**ADDENDUM NO. 1
TO THE
CONTRACT DOCUMENTS**

**CATAWBA COUNTY – BLACKBURN MSW LANDFILL
UNIT 4 CONSTRUCTION
ADVANCE SITE WORK AND UTILITY RELOCATION PROJECT**

BID NO. 25-1019

ISSUED: June 10, 2025

Sheet 03C-01

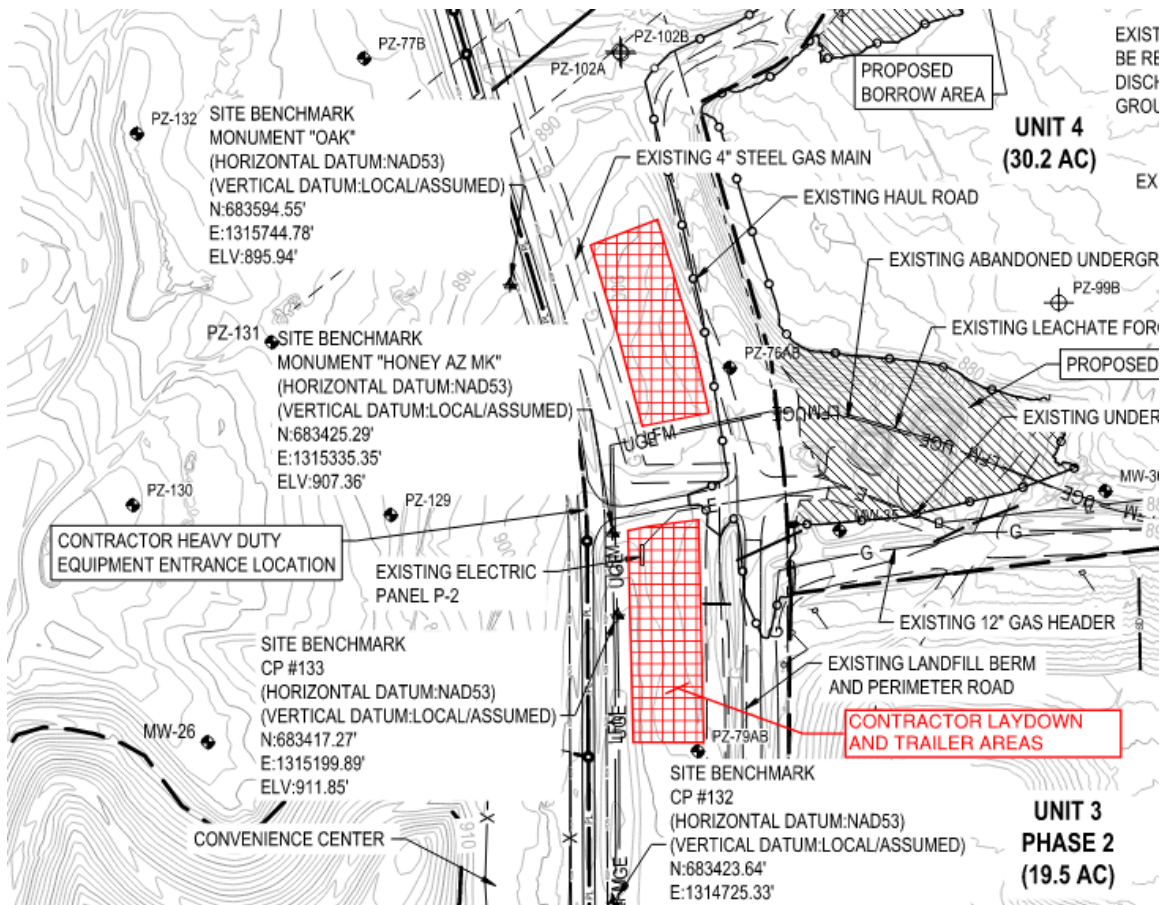
- 1. Add Callout Note to PZ-76AB near Sta 4+00 of Perimeter Road to Read as Follows:

PROTECT AND EXTEND PIEZOMETER TO 12" BELOW FINISHED GRAVEL ROAD GRADE, PROTECT WITH PRECAST ECCENTRIC CONE, FRAME AND COVER
